# UNITED STATES PATENT AND TRADEMARK OFFICE

APPLICATION NO.	FILING DATE	FIRST NAMED INVENTOR	ATTORNEY DOCKET NO.	CONFIRMATION NO.
10/086,653	02/27/2002	Philipp Lang	6750-0001.20	8290

# Office Action Summary

## **DETAILED ACTION**

**Figures 1 & 4 - U.S. Patent 5,917,877 to Chiabrera et al.**

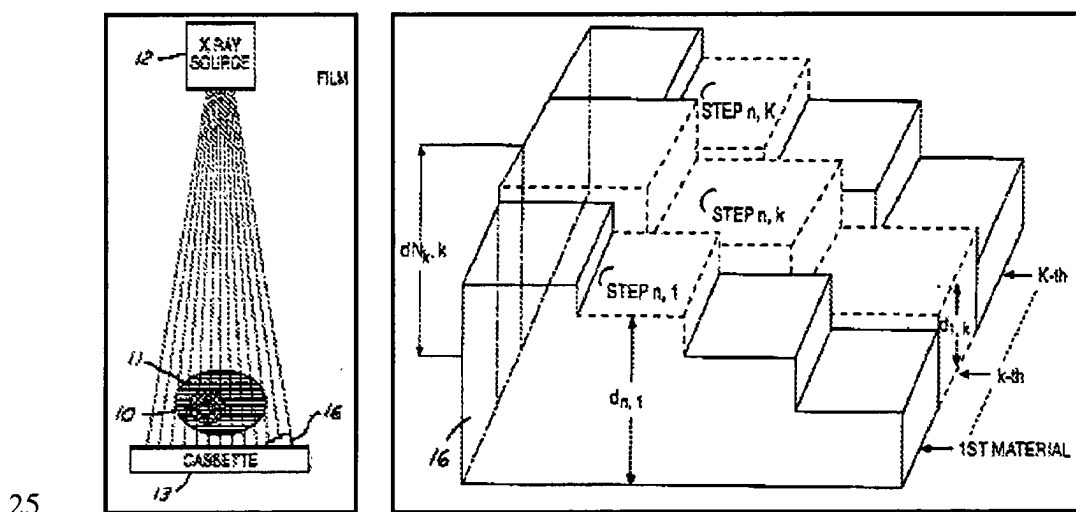
26. As per claims 1-4, 6-7 and 27, Chiabrera et al. disclose an X-ray assembly comprising an X-ray film holder (13), X-ray film ((23) - Fig. 2 – not shown above) a calibration phantom (16), an x-ray imaging assembly and computer programs, wherein said computer programs analyze and assess bone mineral density (see Figs. 1 & 4 above; abstract and respective portions of the specification); wherein the calibration phantom (16) projects free of bone tissue and is

attached to the X-ray film holder or a detector system; and wherein the calibration phantom varies linearly and non-linearly along the length (see Fig. 4, above).

Figure 4 &amp; column 7, lines 34-65 – U.S. Patent 5,852,647 to Schick et al.

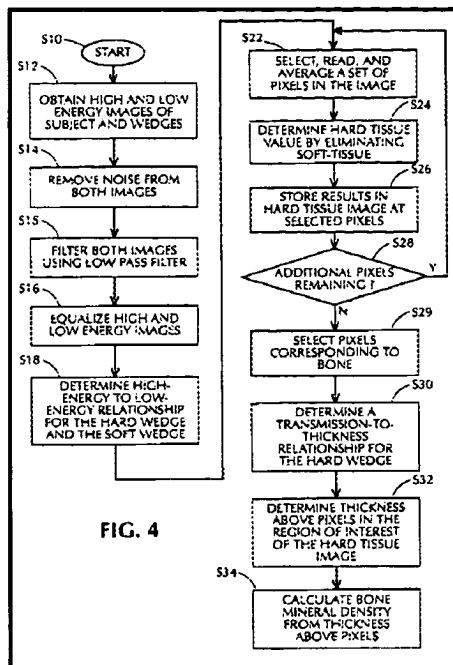
As per claims 8, 9, 11, 13, 14-16, 18-20, 23 and 24, Schick et al. disclose a method comprising the steps of a) providing an X-ray assembly comprising an X-ray film holder, X-ray film (24), and a calibration phantom (12-14), having a length (L) and a varying thickness (T) along the length and b) measuring attenuation at a multitude of points in the X-ray image of the calibration phantom wherein each point is at a known distance from the selected part of the

phantom, thereby generating a calibration curve that describes the relationship between the measured attenuation and material thickness (Fig. 4; column 5, line 47 to column 7, line 65).
